FIELD STONE @ CHESTER SPRINGS
 ASSISTED LIVING FACILITY
 1458 YERS RD
 CHESTER SPRINGS, PA 19375

Sheet Name:	TYPICAL UNITS
Progress Prints:	05/06/2022 PERMIT/BID SET
Revisions:	ADD: 1 CONSTRUCTION SET: 07.1.22
	REVISED: 08.2.22
	BULLETIN: 8.2.23

REVISED

PC, STANDARD, TYPE 5
SCALE: 1/4"=1'-0"

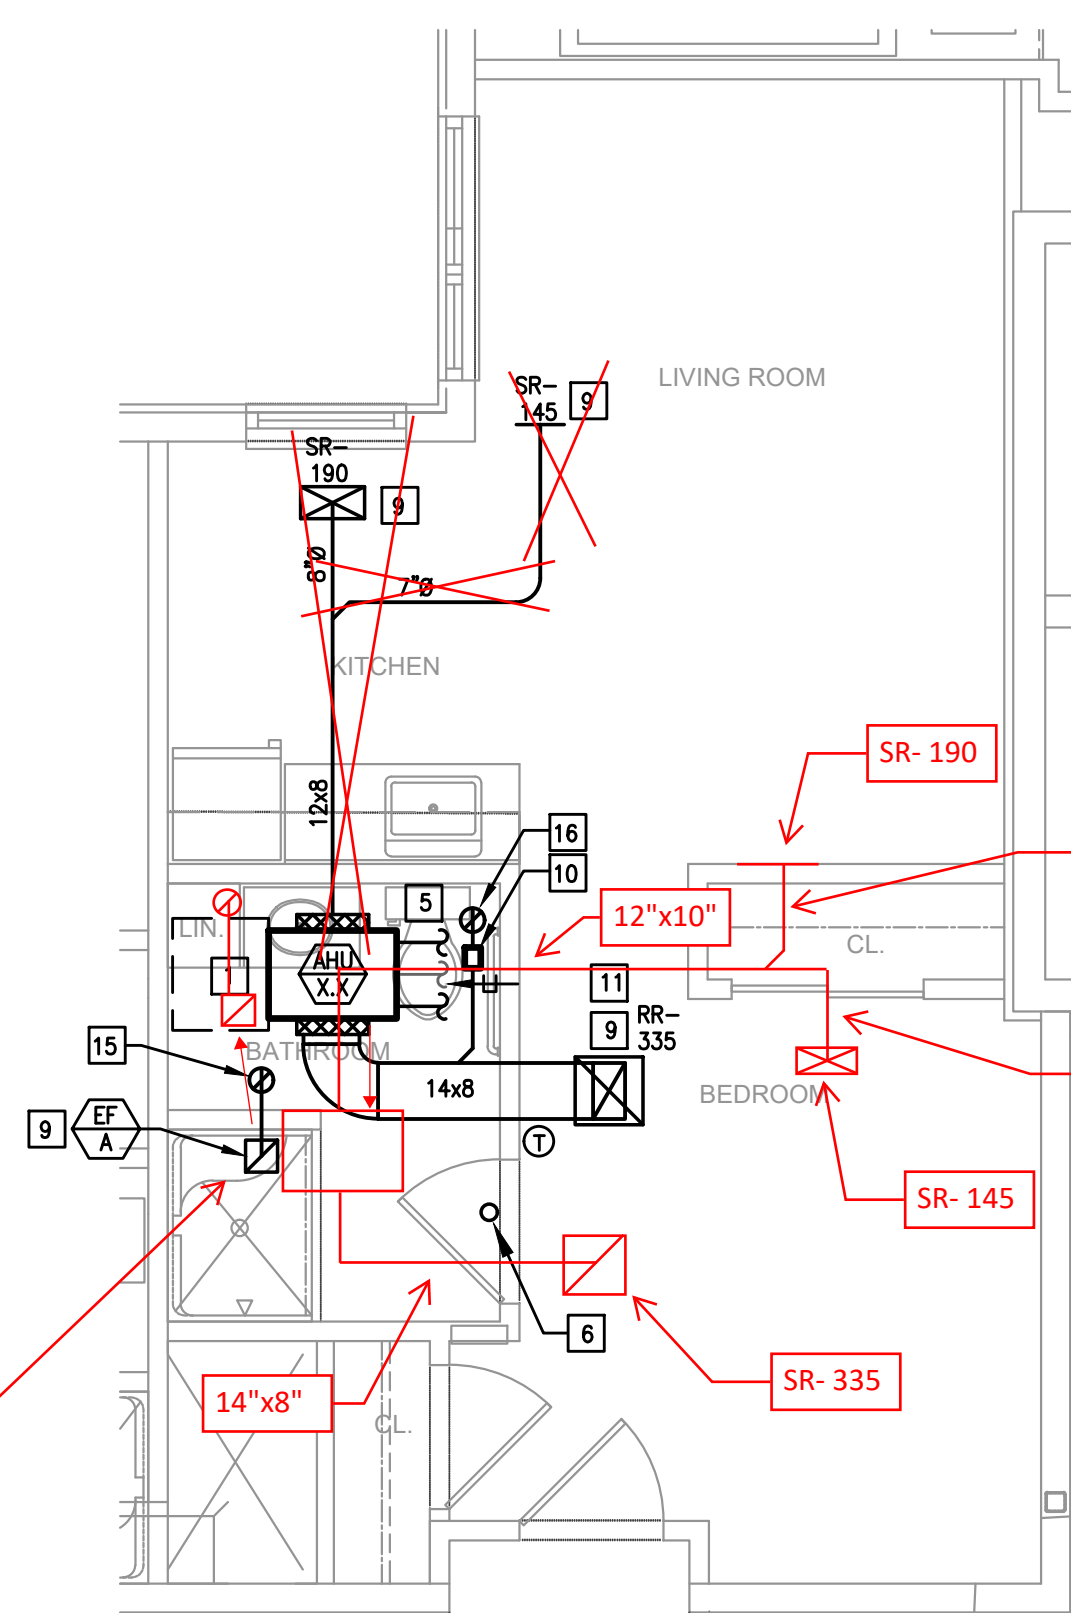
Shift AHU, associated ductwork, and Exhaust to accommodate for ductwork and air device location changes.

PC, STANDARD, TYPE 6
SCALE: 1/4"=1'-0"

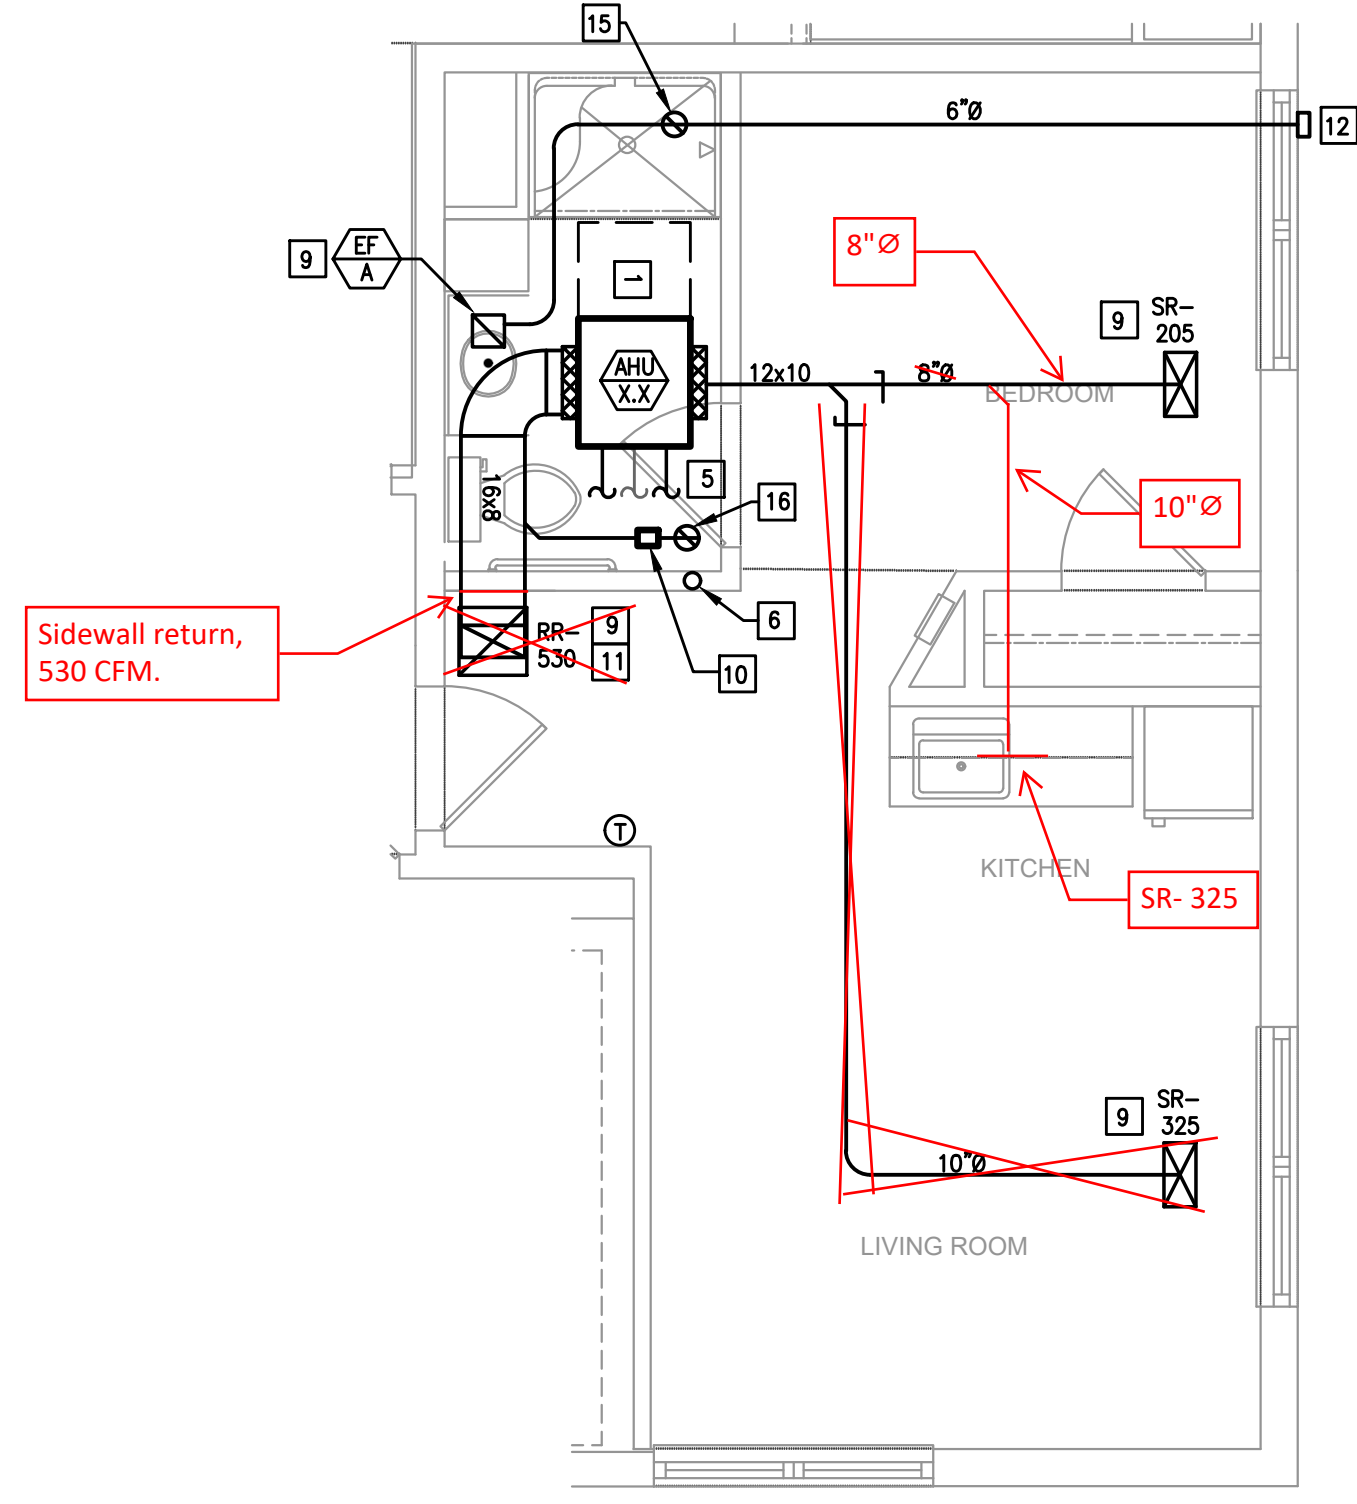
Sidewall return, 530 CFM.

PC, 1 BEDROOM TYPE 1
SCALE: 1/4"=1'-0"

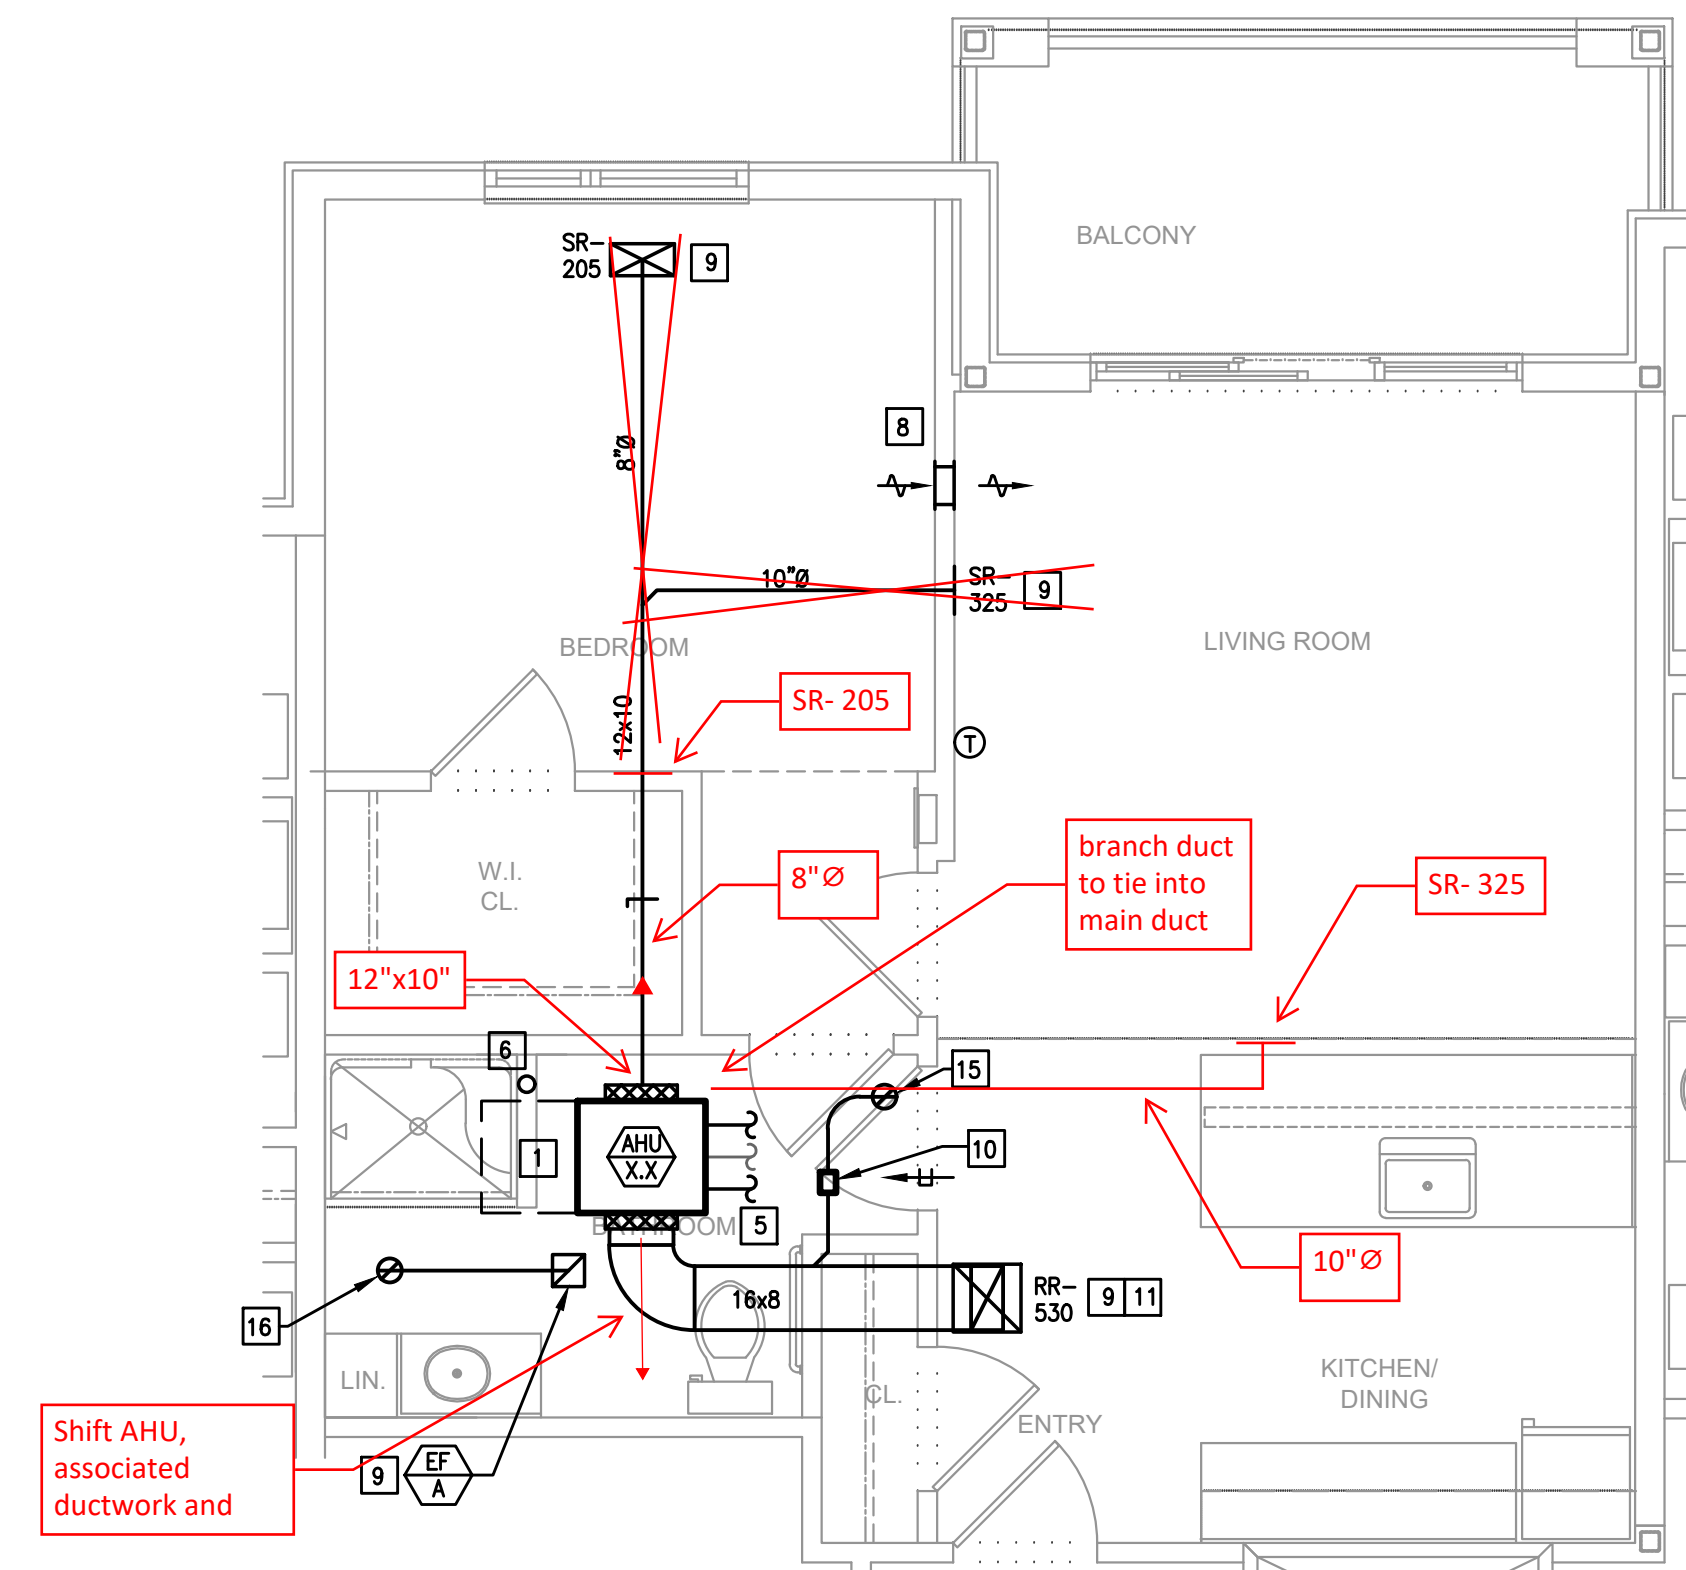
Shift AHU, associated ductwork and

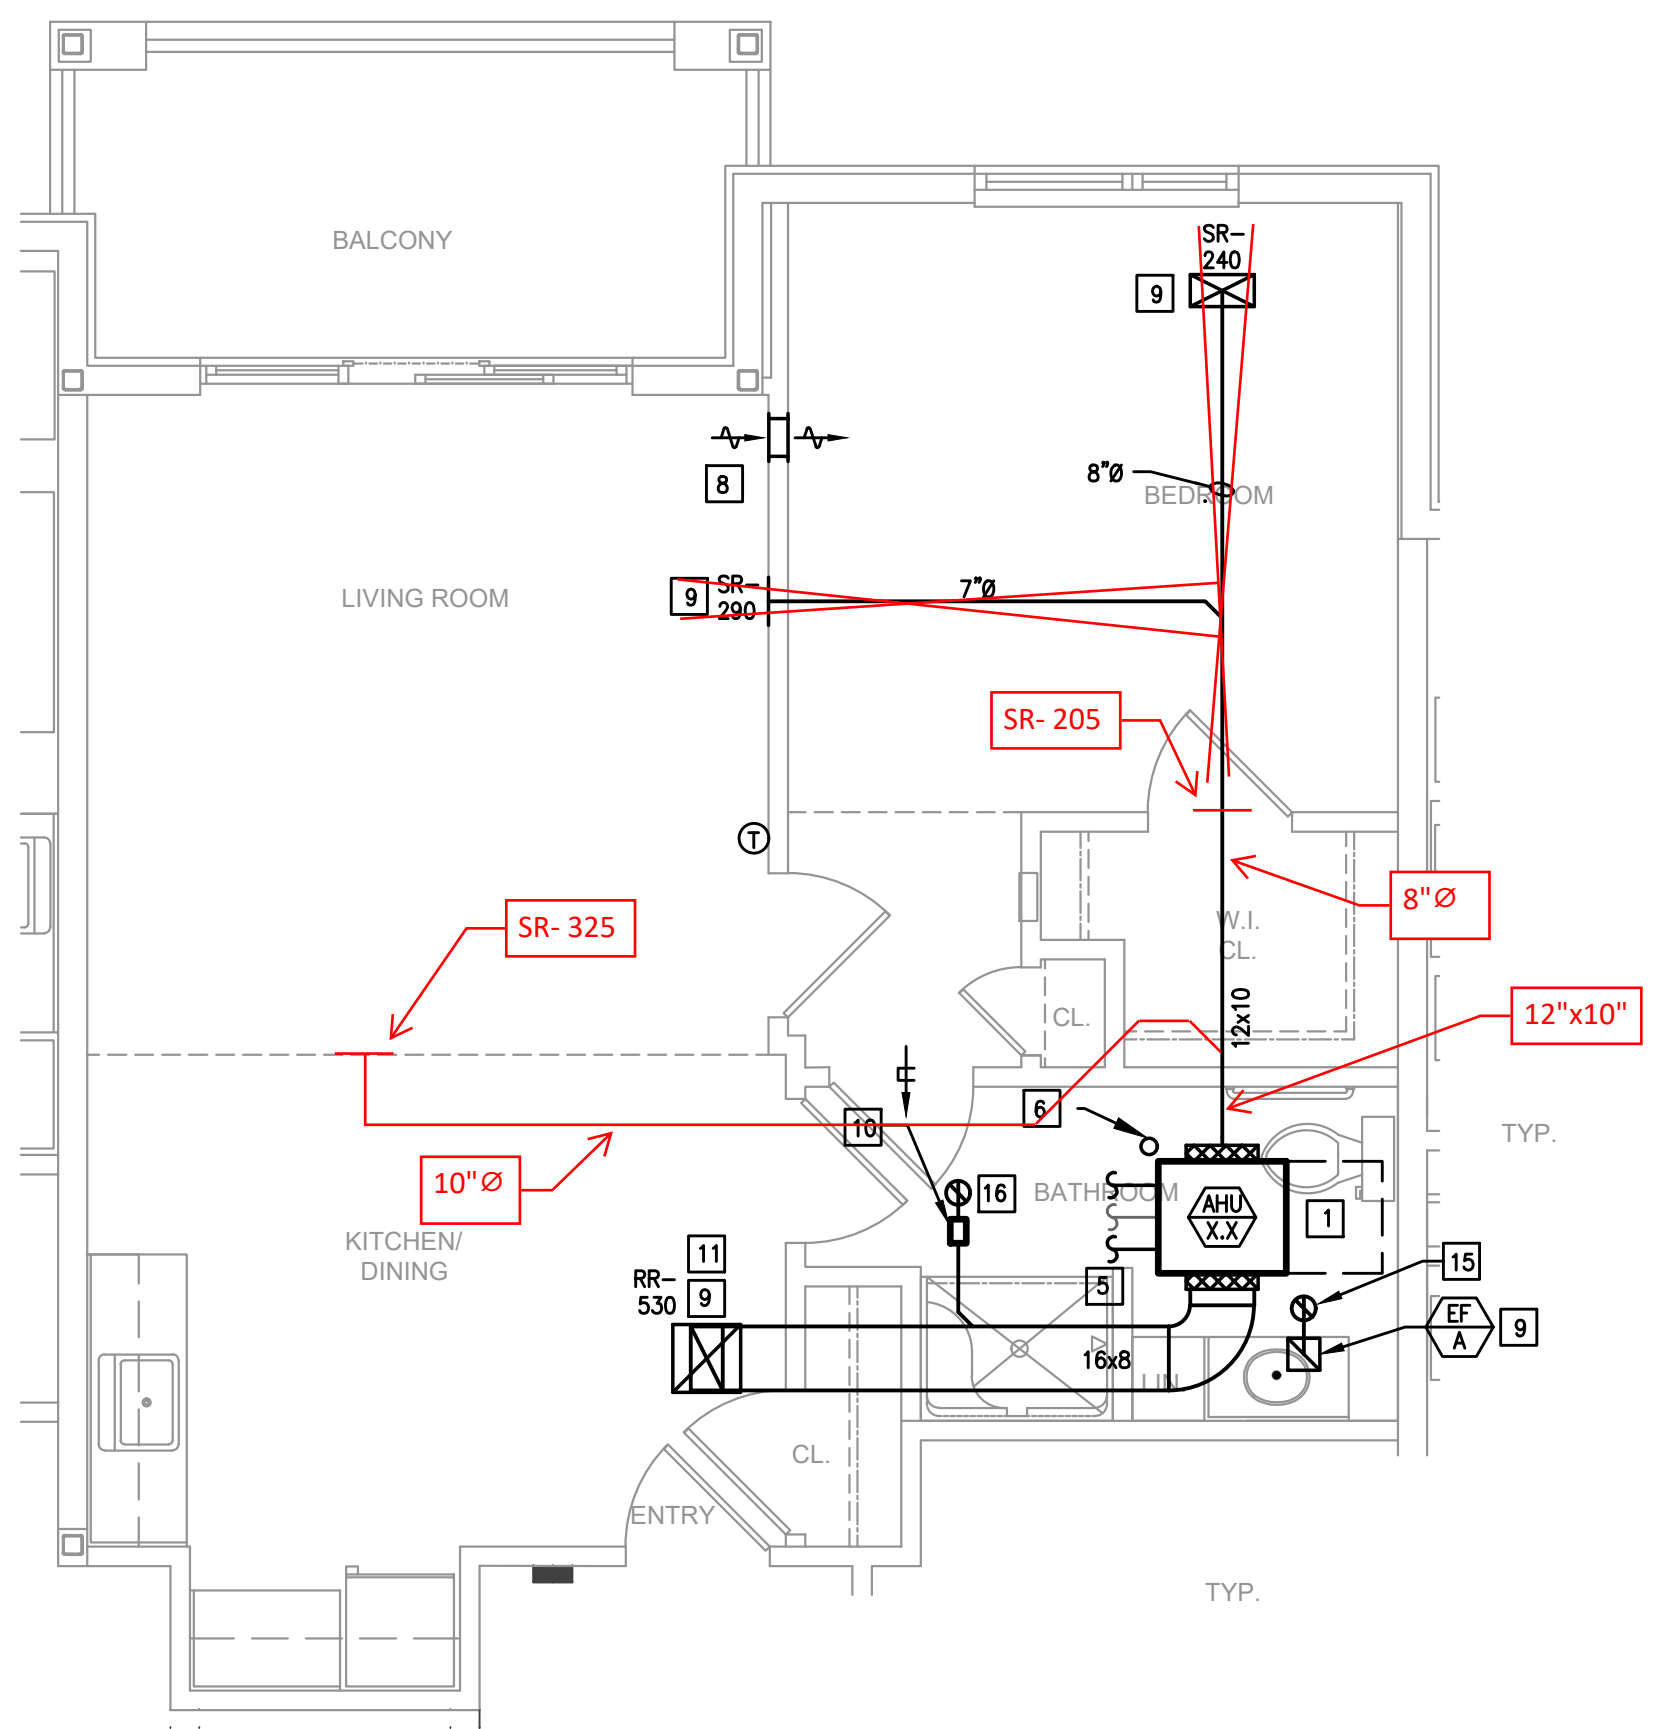
For the third floor units, ductwork is to be removed when shown where a drop ceiling is not located. Air devices are to be located sidewall where the ceilings transition from drop ceilings to the higher ceilings below structure. Refer to markups for routing, sizes, and CFMs.

PC, 1 BEDROOM, TYPE 6
SCALE: 1/4"=1'-0"

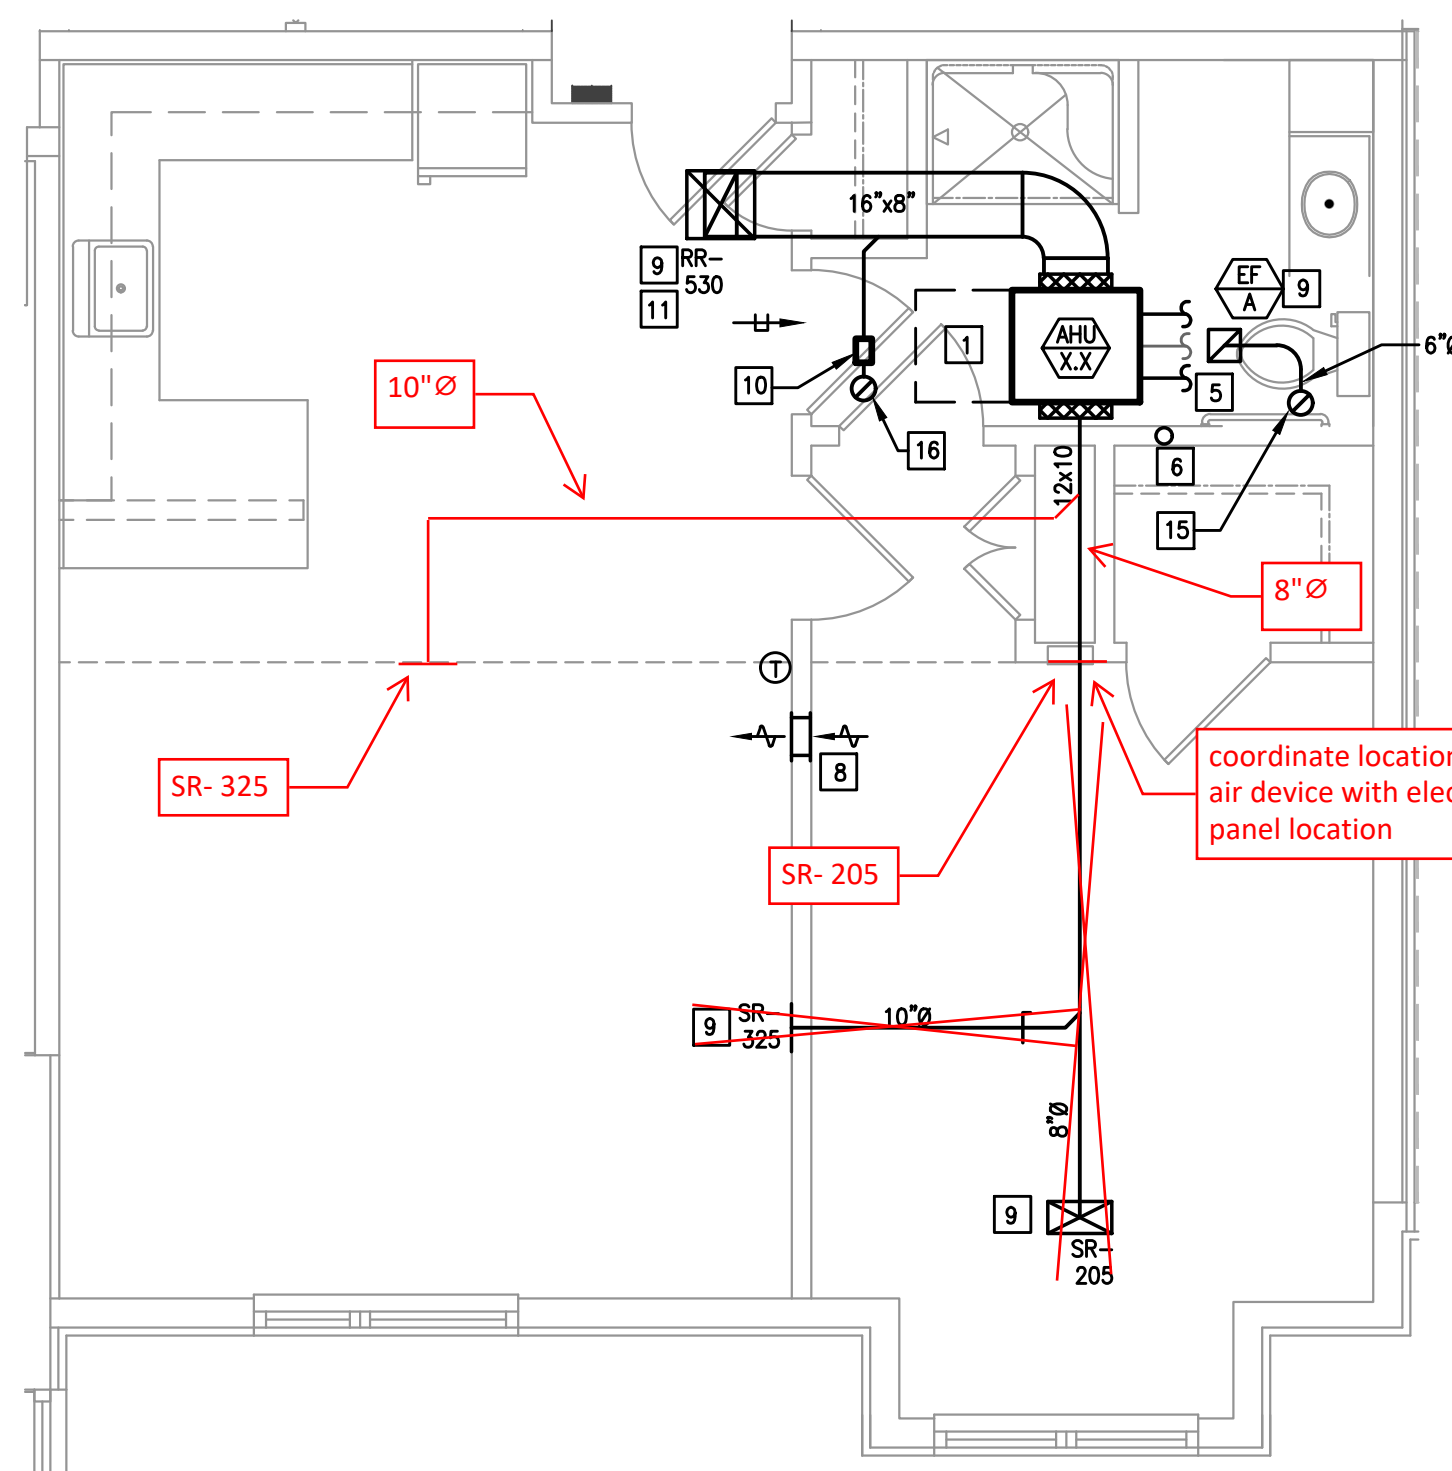
coordinate location of air device with electrical panel location
